# Access Compliance Report

## Public Rights-of-Way

### (Curb Ramps)

Intersection ID: 15211	Main Street: EAST_BV	Cross Street: SCOTT_AV	Location: E
ADA ID: 84493ED0E281	Ramp Type: BlendTrans2	Initial Pass/Fail: Fail	Overall Compliance: No
		Severity Score: 25

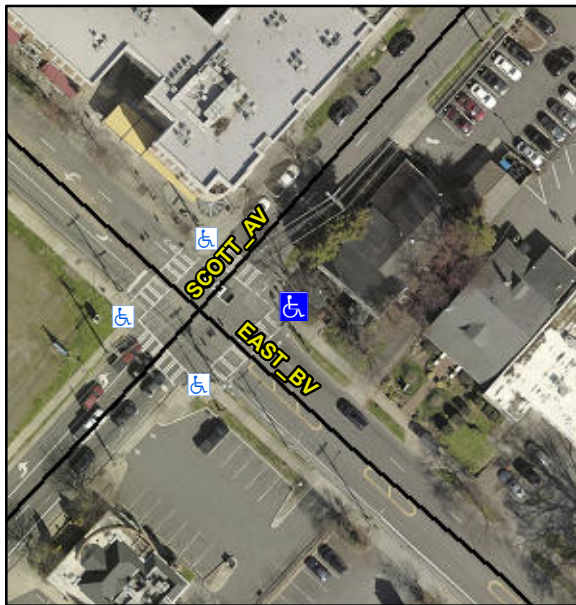
**Not Found, R304.5.3**

Compliance	Description	Data	Compliance	Description	Data
N/A	Ramp Length (in)	<b>66.0</b>	Yes	BlendTrans Slope (%)	<b>3.6</b>
Yes	Ramp Width (in)	<b>130.0</b>	No	BlendTrans XSlope (%)	<b>7.7</b>
N/A	Flare Type LT	<b>N/A</b>	N/A	Flare Type RT	<b>N/A</b>
N/A	Flare Slope LT (%)	<b>N/A</b>	N/A	Flare Slope RT (%)	<b>N/A</b>
N/A	Flare Traversable LT?	<b>N/A</b>	N/A	Flare Traversable RT?	<b>N/A</b>
N/A	Landing Length (in)	<b>N/A</b>	N/A	DWS Provided?	<b>N/A</b>
N/A	Landing Width (in)	<b>N/A</b>	N/A	DWS Contrast?	<b>N/A</b>
N/A	Landing Slope (%)	<b>N/A</b>	N/A	DWS Length (in)	<b>N/A</b>
N/A	Landing X Slope (%)	<b>N/A</b>	N/A	DWS Full Width?	<b>N/A</b>
N/A	Landing Curb? (Y/N)	<b>N/A</b>	N/A	DWS Offset (in)	<b>N/A</b>
N/A	Shared Landing?	<b>N/A</b>			
N/A	Gutter Ponding?	<b>N/A</b>	N/A	Gutter Slope (%)	<b>N/A</b>
N/A	Gutter Lip Ht (in)	<b>N/A</b>	N/A	Gutter X Slope (%)	<b>N/A</b>
N/A	Painted X Walk1?	<b>Yes</b>	N/A	Painted X Walk2?	<b>Yes</b>

**Remove & Replace Curb Ramp With Two New Directional Ramps or Equivalent.**
